PLANNING REPORT

ASTRA DUBLIN 22-133WID-DP

Address	6645 Crosby Court
Proposal	Installation of two new antennas with protective radomes at an existing data center campus located within the West Innovation District (WID).
Request	Review and approval for a Development Plan under the provisions of Zoning Code §153.042(D).
Zoning	ID-3: Research Assembly District
Planning Recommendation	<u>Approval of the Development Plan with Conditions</u>
Next Steps	Upon approval of the Development Plan, the applicant may file for building permits through Building Standards.
Applicant	James Whitacre, Advanced Civil Design
Planning Consultant/ Case Manager	Dan Phillabaum, AICP, RLA Principal • Landplan Studios, LLC (614) 567-2000 dan@landplanstudios.com Taylor Mullinax, Planner I (614) 410-4632 tmullinax@dublin.oh.us

Proposed Site Plan Modifications

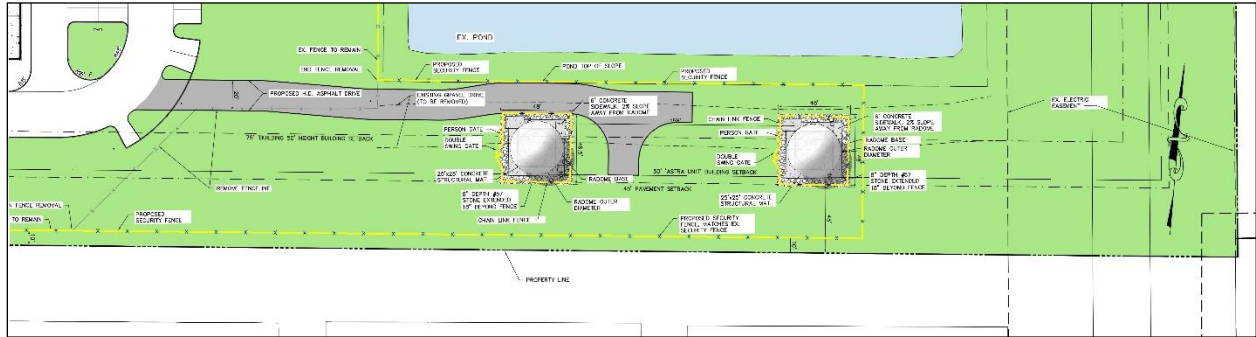
Both antenna sites are proposed to be enclosed within an eight foot tall, black vinyl-coated chain link mesh fence. Chain link fences are not permitted to exceed six feet in height as measured above established grade per Code §153.080(B)(3). To be compliant with Code, the chain link fencing must be reduced to a height not greater than six feet.

A perimeter security fence is proposed to enclose both of the individual chain link fence enclosed antenna sites. This fence matches the existing black aluminum security fence located 10 feet from south property line which currently terminates to the south of the existing bend in the drive aisle located to west of the proposed antenna sites. The security fence will extend westward from this point to enclose the proposed antenna sites, and staff supports the use and extension of this previously approved security fence.

5. The general purposes and spirit of this chapter and the various provisions and components of the Community Plan, including the EAZ Plan.	Criteria met with Condition: The proposed 8-foot high chain link fences enclosing the radomes exceed the maximum height permitted by Code of six feet. Staff recommends that the height of the chain link fence be reduced to six feet or less, to maintain compliance with the Code requirement.

- 1) That the proposed 8-foot tall fence be reduced in height to meet the 6-foot maximum permitted by Code;
- 2) That any relocation of trees be minimized to the maximum extent possible;
- 3) That field verification of tree locations and the proposed limits of the area of disturbance be conducted prior to construction in coordination with Staff; and
- 4) That the existing landscape screening on the mound be augmented with a staggered row of 6-foot-tall Green Giant arborvitae along the area of the proposed radomes.

Proposed Grading Plan Modifications

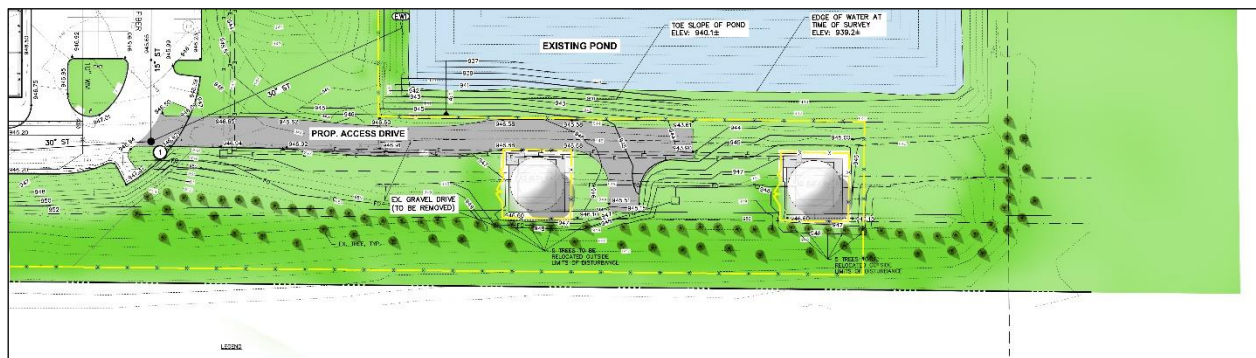
The location of the proposed antenna sites is in the area of an existing five foot high landscaped mound which serves as a buffer along the southern property line to Darree Fields. To accommodate the antenna sites and access drive, modification to the existing contours on the north side of the mound and potential relocation of several well-established evergreen trees is proposed. The existing trees are proposed to be relocated outside of the area of disturbance to the existing mound.

Staff has concerns about the long-term viability of these existing trees after the proposed relocation. These evergreens are well-established in their current location, and transplanting could stunt their growth for several years. To address these concerns, Staff recommends the ART consider several Conditions of Approval. Any relocation of trees should be minimized to the maximum extent possible. In coordination with Staff, field verification of tree locations and the proposed limits of the area of disturbance should be conducted prior to construction. To assist in filling in gaps to the landscape buffer resulting from the relocation of existing evergreens, Staff recommends the landscaping be augmented with a staggered row of six-foot-tall Green Giant arborvitae (*Thuja 'Green Giant'*) along the area of the radomes. This species has a fairly rapid rate of growth—up to 3 feet per year, to a potential height of 50 feet under ideal conditions. Finally, the potential use of retaining walls should be evaluated by the applicant to minimize disturbance to the north side of the existing mound.

The total area of additional impervious surface to be added to the site with this proposal is 10,515 square feet. Engineering has verified stormwater data provided by the applicant indicating that the existing retention ponds were sufficiently sized at the time of construction to accommodate the additional runoff resulting from the proposed increase in impervious surface, including the proposed modifications to the contours in the southwest corner the retention pond.

The proposed access drive alignment requires that the contours of the southwest corner of the retention pond to the north be modified. A minimum three-foot grading buffer is recommended beyond the north edge of the access drive before grading begins to slope down to the basin, as well as a minimum two-foot horizontal clearance between the edge of the access drive and the edge of the proposed security fence.
